**Re: Massey Tunnel Replacement Project
Cycling improvements in Highway 99 Corridor - 2016 Update**

This document is an update to the HUB Cycling submission (2014) which was made to the MoTI project team in July, 2014. Since 2014, we have had much feedback from the cycling community about the proposed bridge and Highway 99 corridor changes. We have reviewed the latest design proposals from the project team and have refined our suggestions.

Improvements North of Westminster Highway

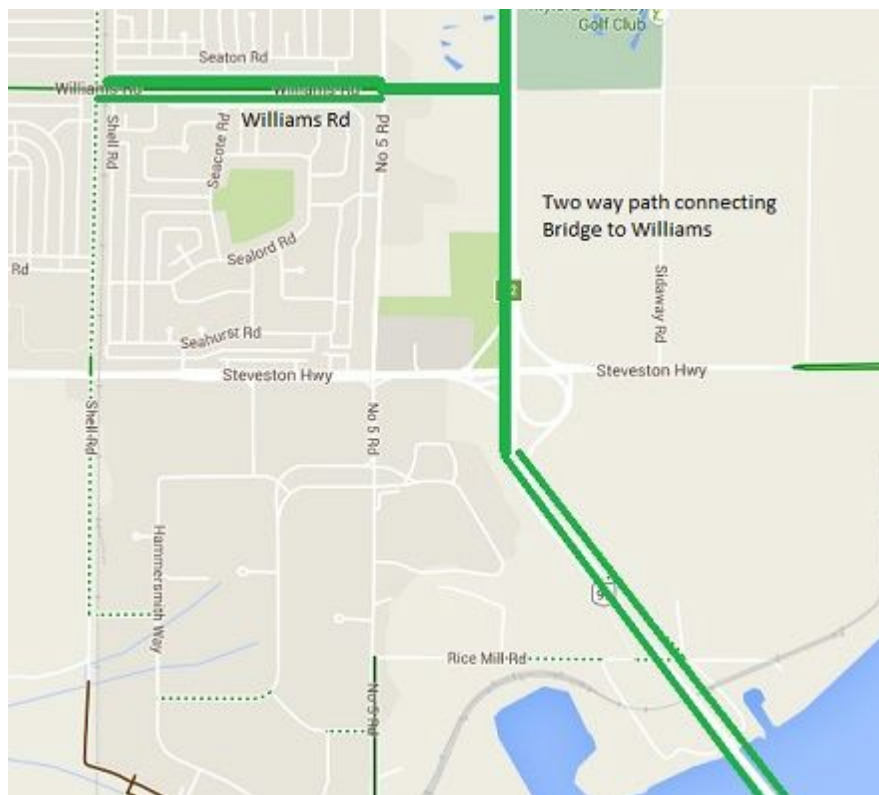
There is currently a major gap in the regional cycling network between the intersection of Shell Road with Highway 99 and the Oak Street and Canada Line bridges. Filling this gap with proper cycling infrastructure should be included into the scope of the project. This could be done by adding a bikeway inside the Highway 99 corridor which is separated from motor

vehicle traffic. Note that cycling access to the Oak Street Bridge - especially the east sidewalk - is now neither safe nor convenient and should be improved.

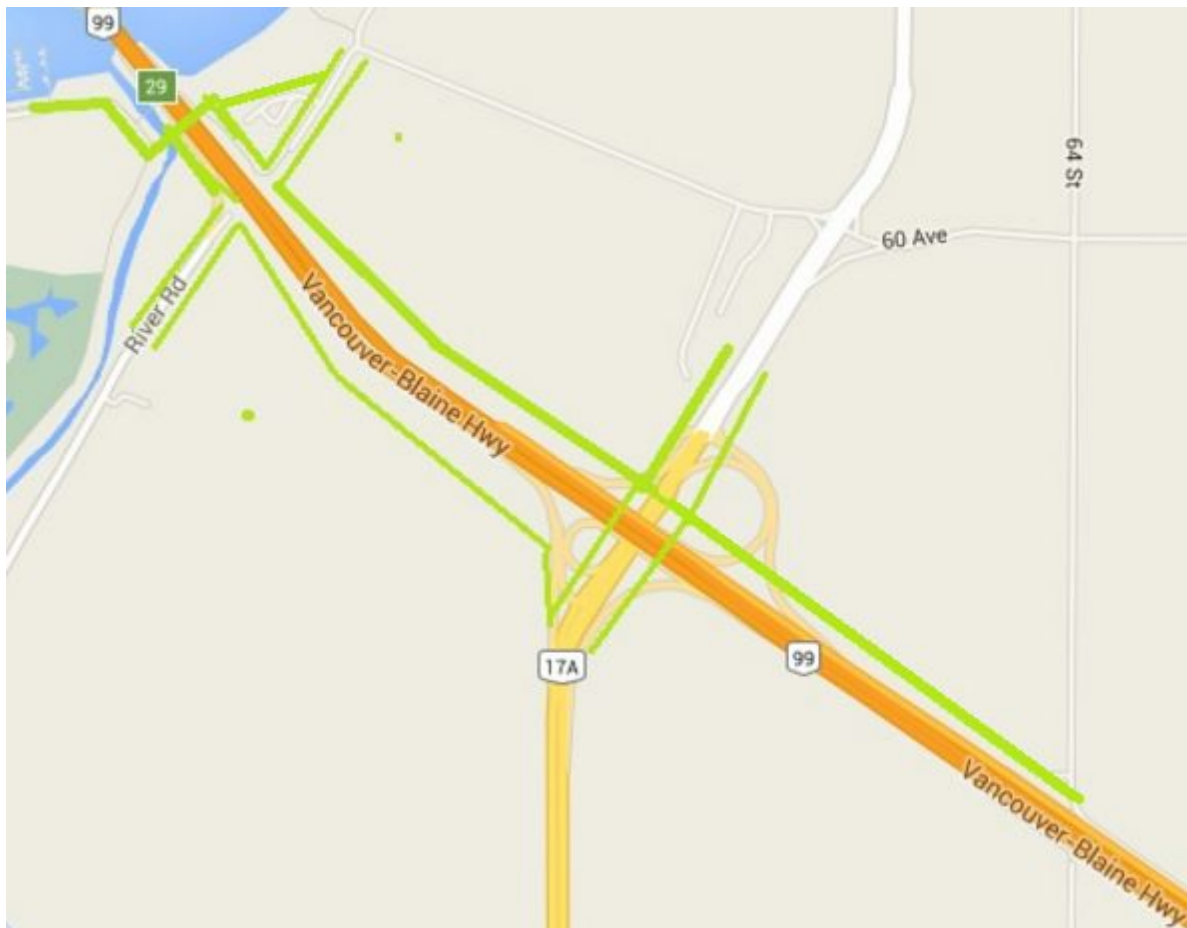
Proposed changes to the intersection with Hwy 17A provide an opportunity to integrate the cycling network into the intersection design, including safe and convenient access to the proposed integrated transit stops. We recommend the following improvements:

- Connection to and retaining of the Millennium Trail, with a more direct connection to the segment to the west of the freeway.
- Connection to River Road and improved cycle safety on the Vasey Road / 60 Avenue corridor.

- Add a one-way bikeway along the west side of Hwy 99 as far as the Hwy 17A exit.
- Add two-way bikeway along the east side of Hwy 99 at least as far as Burns Drive/64th St. with grade separation at all road crossings. Routing should be as direct as that afforded to freeway motor vehicle traffic.
- Provide separated bikeways on any new freeway overpasses.
- A nice to have addition: The new bridge provides a great opportunity to provide improved access to Deas Island for those walking and cycling. This could be accomplished by adding a pedestrian/cycling ramp which connects the west end of Deas Island to the Massey Tunnel replacement bridge. This ramp would allow more direct cycling and walking access to Deas Island for the residents of Ladner.
